ADDENDUM 01

July 24, 2026

Bradford Exempted Village Schools
New Athletic Facility
760 Railroad Avenue
Bradford, OH 45308

LPA PROJECT NO. 263401.00

26 HOME LOCKER ROOM ENLARGED FLOOR PLAN

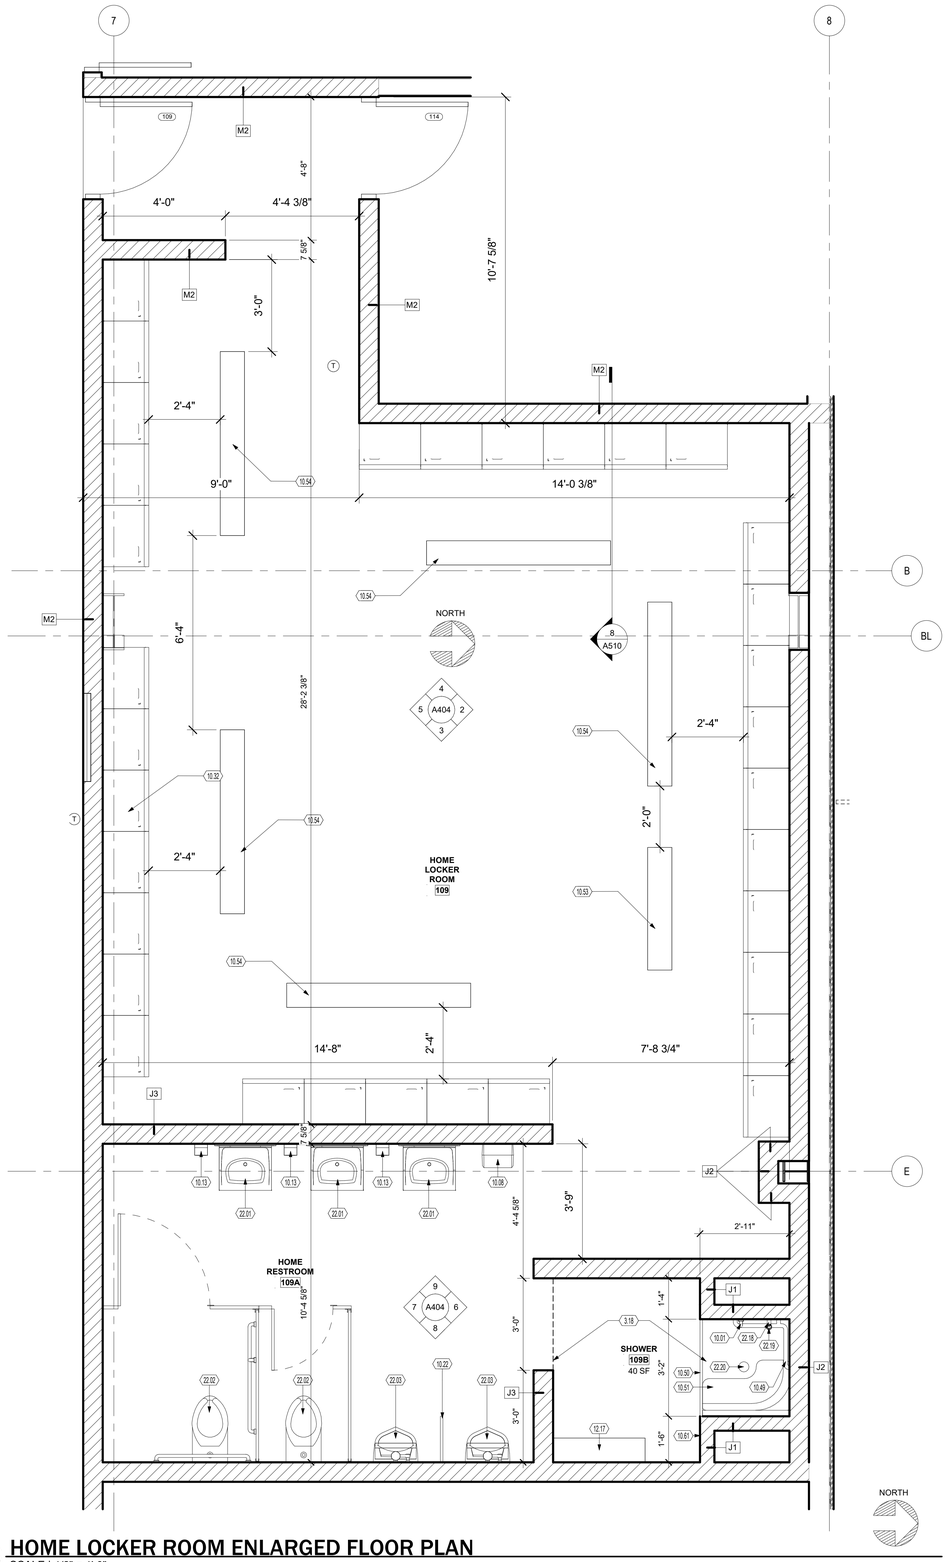
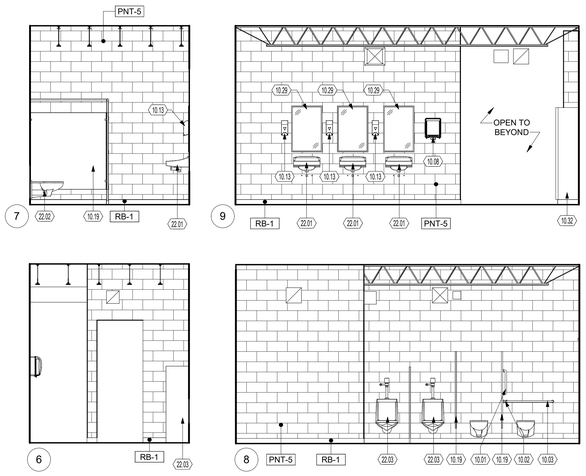
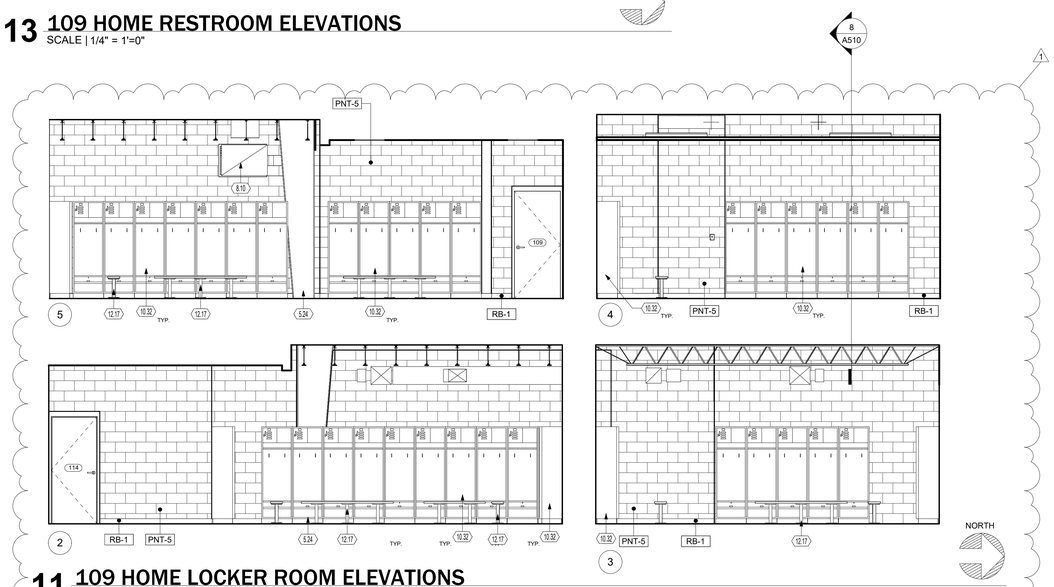
2.16 Sheet A404 – RESTROOM PLANS AND ELEVATIONS.

2.16.1 Added basis of design diaper changing station to RR ACCESSORY SCHEDULE.

2.16.2 Added basis of design mirror to RR ACCESSORY SCHEDULE.

2.16.3 Revised note 10.32 adding a 14 gauge metal base provided by the locker manufacturer. Indicated base on the interior elevations.

28 SPLIT FACE WAINSCOT @ GYM
SCALE | 1 1/2" = 1'-0"

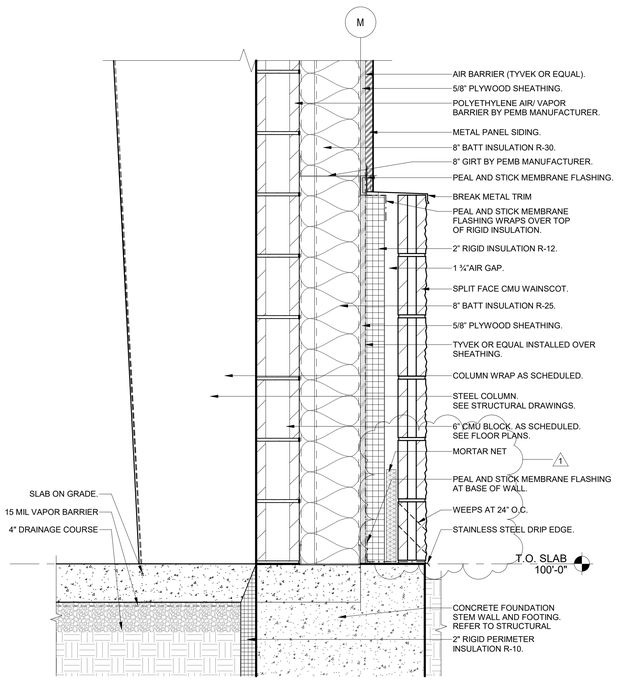
2.17 Sheet A501 – EXTERIOR DETAILS.

2.17.1 Added mortar net behind the split face CMU in detail 28.

9 GIRT METAL PANEL CONNECTION
SCALE | 3" = 1'-0"

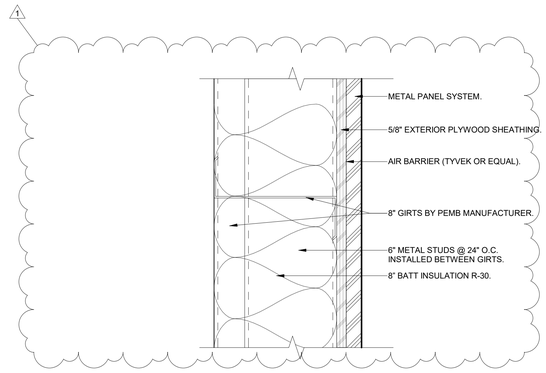
2.18 Sheet A502 – EXTERIOR DETAILS.

2.18.1 Revised detail 9 to reflect R-30 batt insulation.

26 MAIN ENTRY CANOPY SECTION
SCALE | 3/4" = 1'-0"

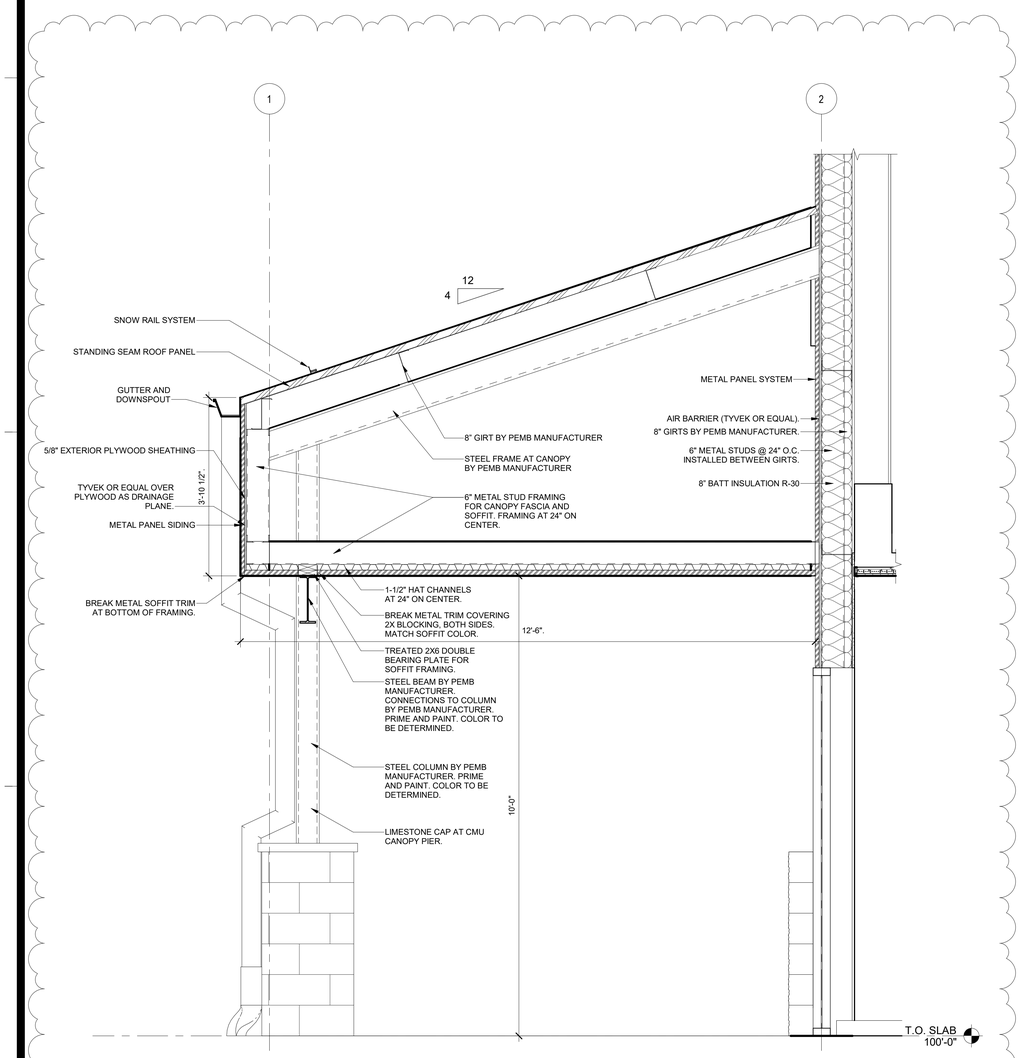
2.19.1 Added Section 26 for the main entry canopy.

1.6.1 Response: The ceiling for the front entrance canopy is a metal panel soffit similar to Berridge L-Panel with an embossed stucco texture and vee grooves. This will be installed on 6” metal studs at 24” on center with 1-1/2” hat channel furring at 24” on center. See attached detail 26 on sheet A503 for the section / detail.

13 ALTERNATES G-8 AND G-9 - LIMESTONE WAINSCOT CAP
SCALE | 1 1/2" = 1'-0"

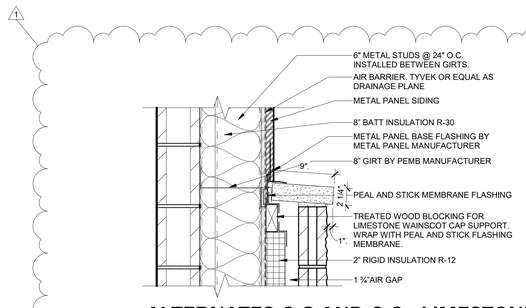
2.19.2 Added detail 13 showing the alternate limestone water table.

12 PORCH COLUMN PIER SECTION
SCALE | 1 1/2" = 1'-0"

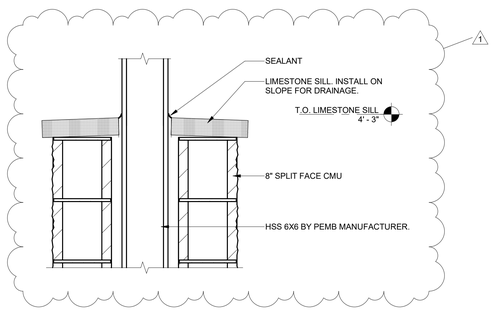
2.19.3 Revised detail 12 showing the limestone cap on the main entrance canopy column piers. The limestone caps on the canopy piers are base bid.

11 DETAIL @ MEZZANINE RAILING
SCALE | 1 1/2" = 1'-0"

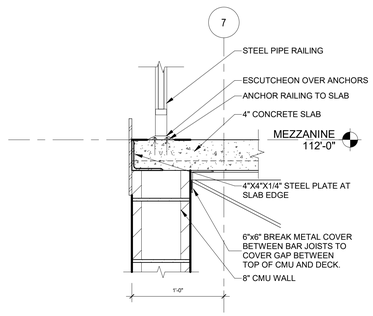
1.3 Question: Details 6 and 11 on sheet A503 show a break metal cover at the top of the wall. Where does this go?

2.19.4 Revised detail 11 showing an escutcheon over the railing anchors at the floor.

1.3.1 Response: The 6x6 break metal cover is installed in the vistor and home locker rooms and restrooms at the top of the CMU wall to cover the gap between the top of the wall and the metal deck. It should be installed in these areas where there is no ceiling. The break metal should be white. This should also be installed in Vestibule 107.

13 (ALTERNATE) WEIGHT ROOM STORAGE CLOSET
SCALE | 3/4" = 1'-0"

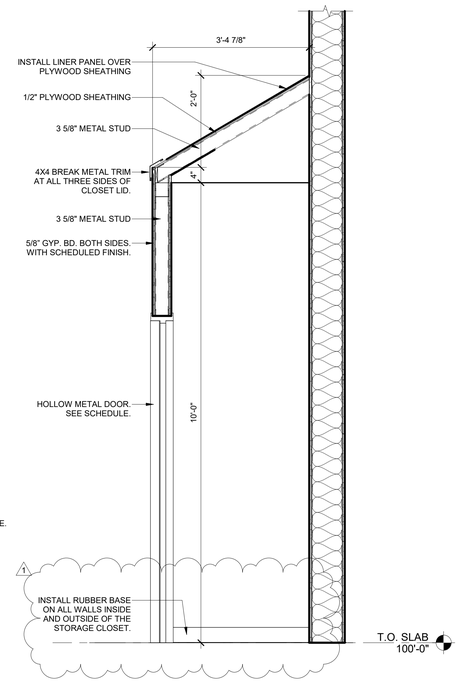
2.20.2 Revised the alternate weight room storage closet detail 13. Clarified that rubber base is to be installed both inside and outside the storage closet.

6 MEZZANINE STORAGE CLOSET
SCALE | 3/4" = 1'-0"

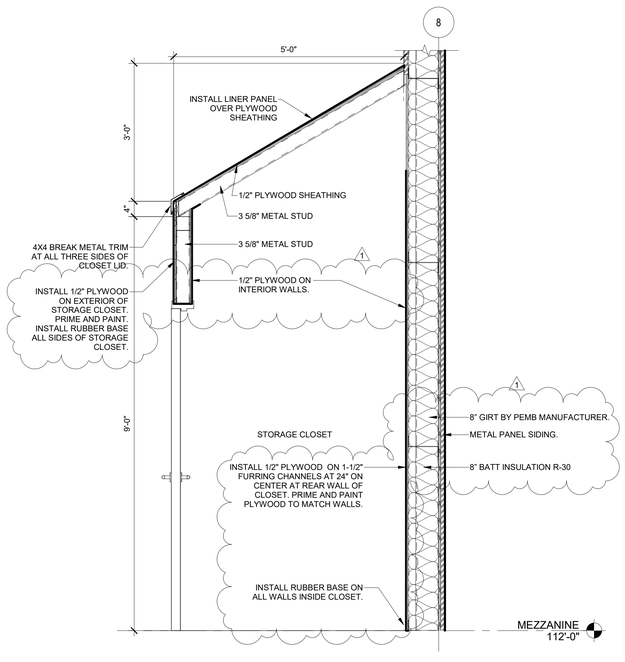
2.20.1 Revised mezzanine storage closet detail 6. Closet shall have ½" painted plywood on the exterior and interior. Install rubber base on the exterior and interior of the closet.

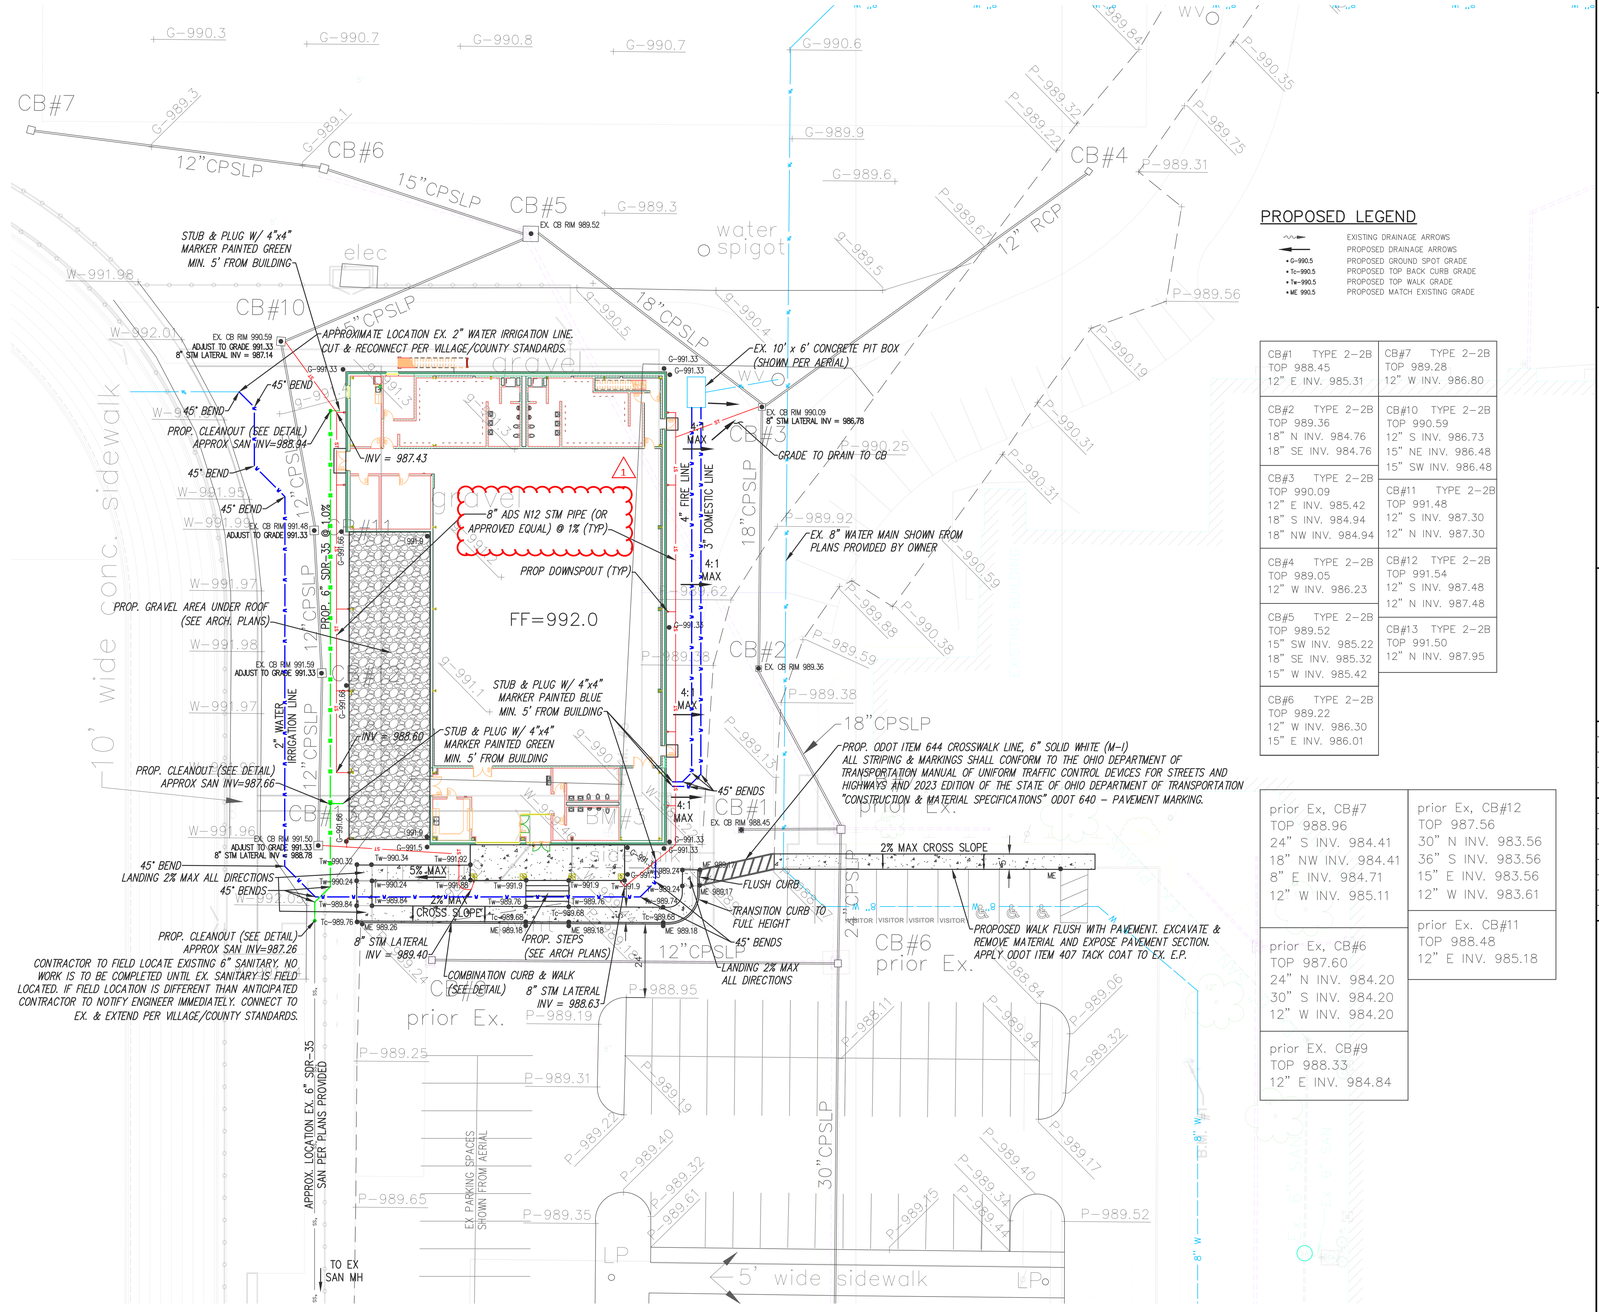
1.7 Question: Are the storm downspouts surface drained or tied into the storm sewer?

2.1 Sheet C3 – SITE PLAN AND SITE UTILITES.

2.1.1 Added perimeter drain for downspouts.

1.7.1 Response: All downspouts at the building are tied into a perimeter drain system. See attached revised sheet C3 for the perimeter drain and connection to the storm sewer.

FIRST FLOOR PLAN - LIGHTING
SCALE: 1/8" = 1'-0"

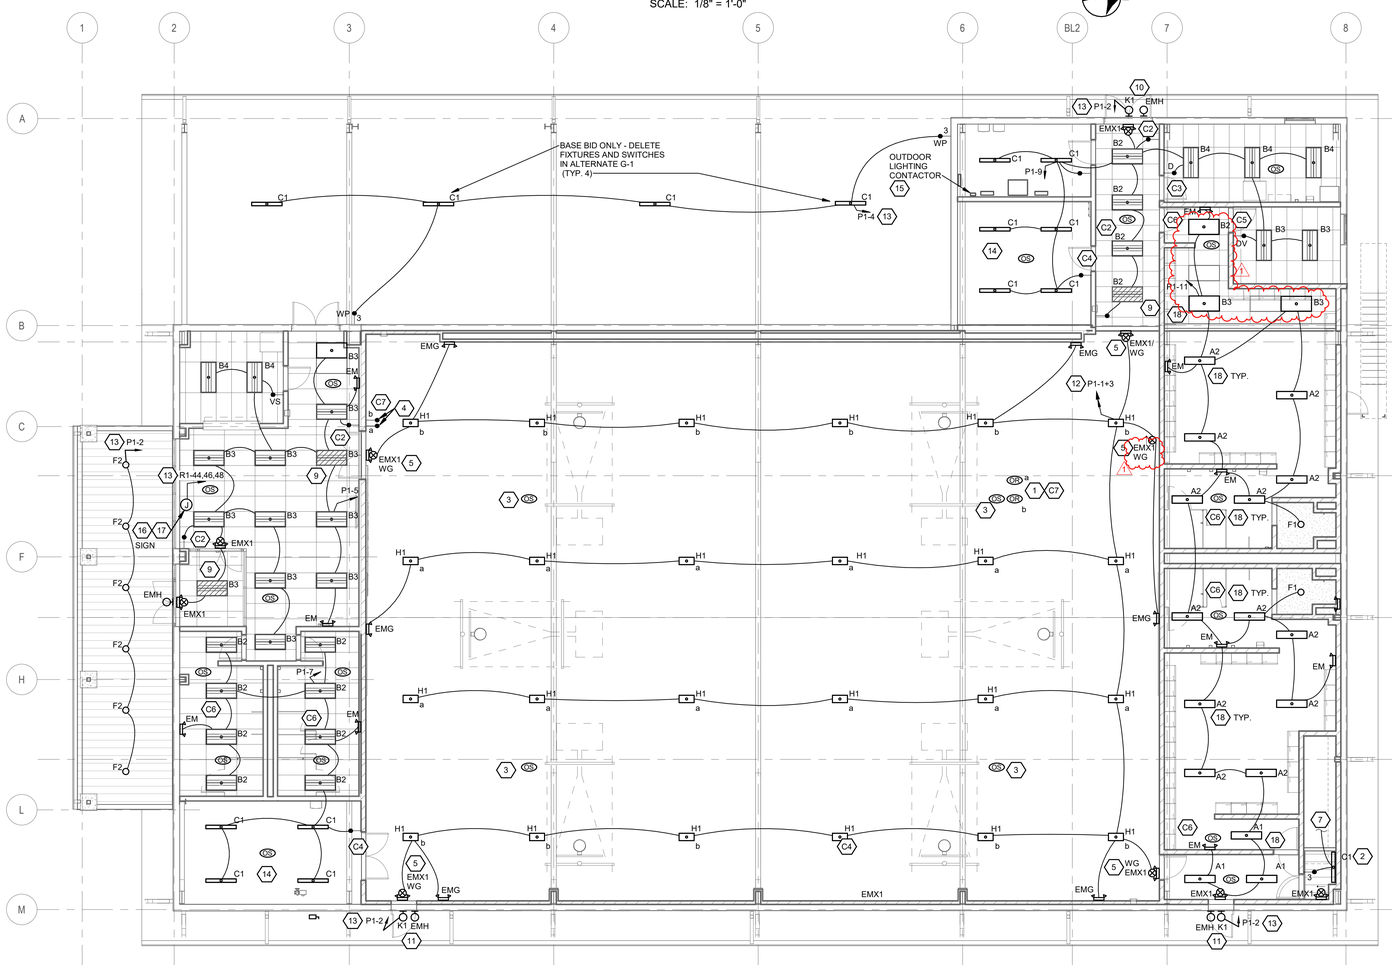
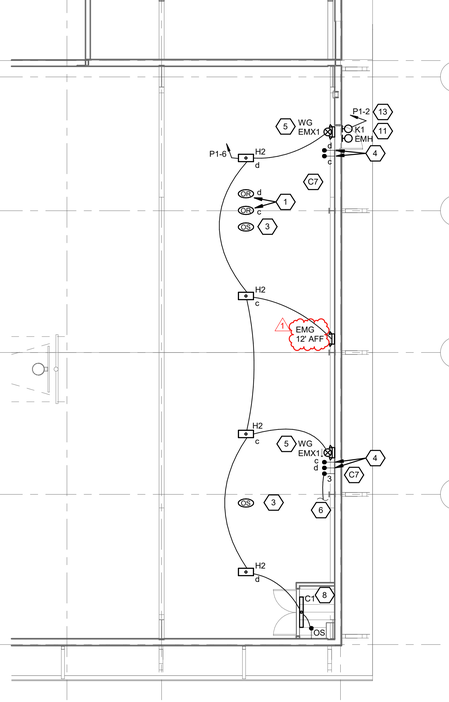
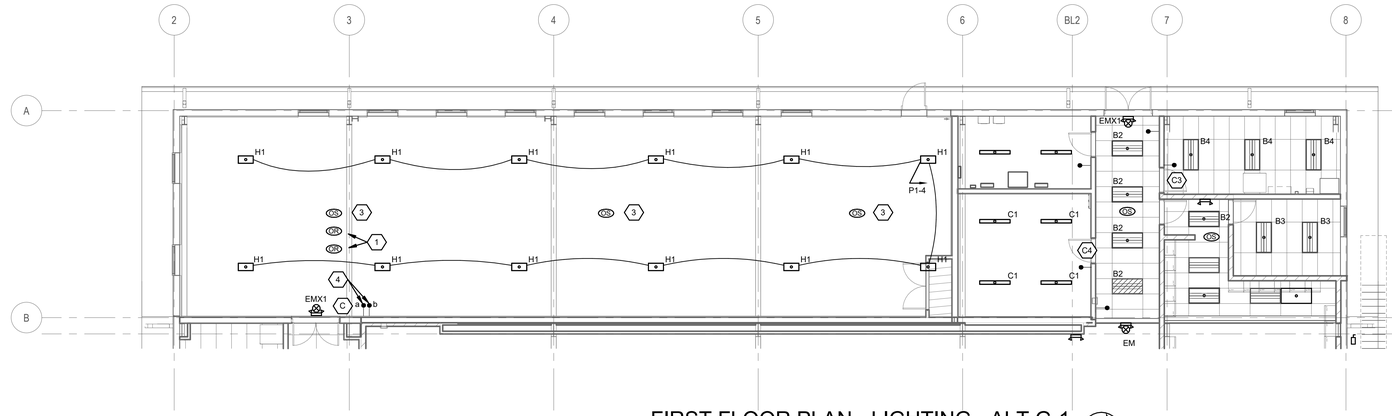
1.8 Question: On sheet E1.1 in the top right corner of the gym there is an exit fixture type ‘X1’, that fixture is not on the fixture schedule. Please clarify.

1.9 On sheet E1.1 on the mezz detail there is a fixture type 'EMS', that fixture is not on the fixture schedule. Please clarify.

2.23 Sheet E1.1 – FIRST FLOOR AND MEZZANINE FLOOR PLANS – LIGHTING.

2.23.1 Revise portion of Locker Room light fixtures to lay in fixtures in lay in ceiling; and miscellaneous revisions. Refer to drawing issued with Addendum.

2.23.2 Revise Keynote 17 for the exterior sign. Rough-ins are included in the base bid. The sign will be provided and installed by the Owner at a later date.

1.8.1 Response: See the attached revised sheet E1.1 clarifying the fixture type.

1.9.1 Response: See the attached revised sheet E1.1 clarifying the fixture type.
